Office Action Summary

10/785,209

HOHMANN, RONALD P.

Lapish (US 5,035,099)

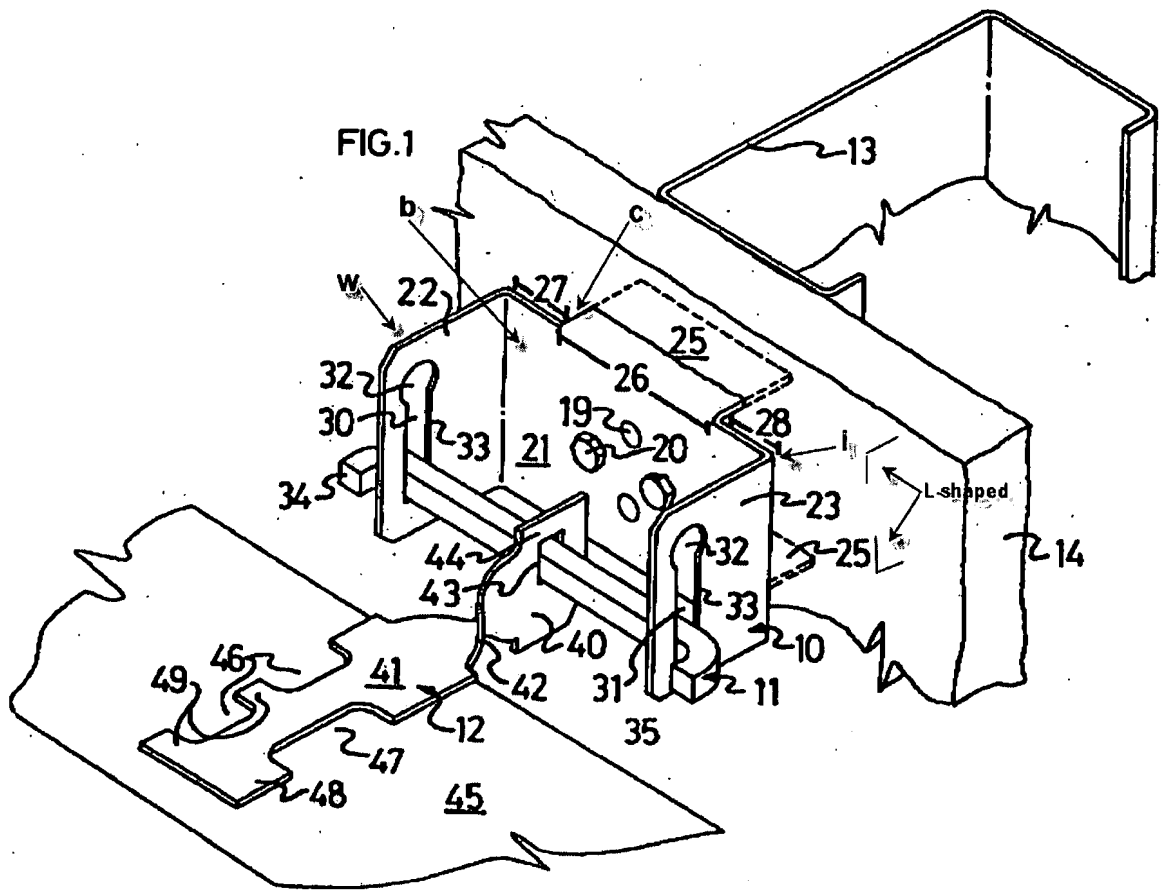
Regarding claims 1 and 13, Lapish discloses an anchoring system having a wall anchor (10) constructed from a plate-like body (b) having two major faces being the mounting surface (i) and the outer surface (21), said wall anchor, in turn, comprising; a pair of legs (25), each extending from said mounting surface of said plate-like body from an inboard location thereof with the longitudinal axis of each of said legs being substantially normal to said mounting surface (i), (annotated Figure 1).

a covering portion (c) formed at said mounting surface (i) of said plate-like body,

an apertured receptor portion (30, 31) adjacent said outer surface (21) of said plate-like body (b), (annotated Figure 1). The phrase "adapted to limit displacement of said outer wythe toward and away from said inner wythe" is considered intended use and is given no patentable weight.

and, a veneer tie (11, 12) threadedly disposed through said apertured receptor portion (30, 31), (annotated Figure 1). The phrase "and adapted for embedment in said bed joint of said outer wythe to prevent disengagement from said anchoring system" is considered intended use and is given no patentable weight.

Lapish does not disclose the legs having a channel along said axis adapted for sheathing mounting hardware. However, Frobosilo teaches a leg (14) having a channel (28) along said axis, (Figure 1). Therefore, it would have been obvious to a person having ordinary skill in the arts at the time of the applicant's invention to modify the legs of Lapish to include a channel as taught by Frobosilo that would provide the option of having an additional attachment between the leg and the layer of insulation.

Lapish does not disclose at least one strengthening rib impressed in said plate-like body parallel to said apertured receptor portion. However, Wilhelmi teaches a bracket assembly having at least one strengthening rib (23) impressed in said plate-like body parallel to an apertured receptor portion (4.1). Therefore, it would have been obvious to a person having ordinary skill in the arts at the time of the applicant's invention to modify the anchoring system of Lapish to include at least one strengthening rib parallel to said apertured receptor portion as taught by Wilhelmi, as it is well known in the art to add ribs to sheet metal members, as they provide reinforcement by adding strength and rigidity to the sheet metal.
